Mitsubishi Motors North America, Inc.

**SERVICE / DEALER PDI CAMPAIGN ECU
(ENGINE CONTROL UNIT) REFLASH**

No: SC-26-002

2026 Outlander with 4B40 Gen 2 Engine

REPROGRAMMING PROCEDURE

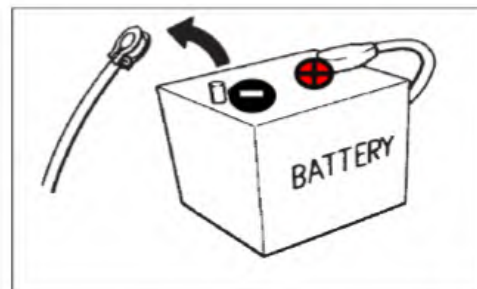
This software update addresses fault codes P0128-00, P2096-00 and P050A. Ensure the **MUT3-SE software version is #994 or higher**, and perform the procedure below:

Model	Data No.	New HW Part No.	New SW Part No./Ver.	Target HW Part No.	Target SW Part No./Ver.		Remarks
					After P0128 reprogramming	Before P0128 reprogramming	
Outlander	23761W41.9PN	-	23761W419P	23703W013P	23761W361P	23761W277P	2WD CRUISE CONTROL
	23761W42.0PN	-	23761W420P		23761W362P	23761W278P	2WD ADAPTIVE CRUISE CONTROL
	23761W42.1PN	-	23761W421P		23761W363P	23761W279P	2WD MI-PILOT Assist
	23761W42.2PN	-	23761W422P		23761W364P	23761W280P	4WD CRUISE CONTROL
	23761W42.3PN	-	23761W423P		23761W365P	23761W281P	4WD ADAPTIVE CRUISE CONTROL
	23761W42.4PN	-	23761W424P		23761W366P	23761W282P	4WD MI-PILOT Assist

* If the software part number matches SW Part No./Ver. highlighted by **yellow** above, perform a battery reset after ECU reprogramming. Otherwise, DTC P2096 may recur due to retained learned values.
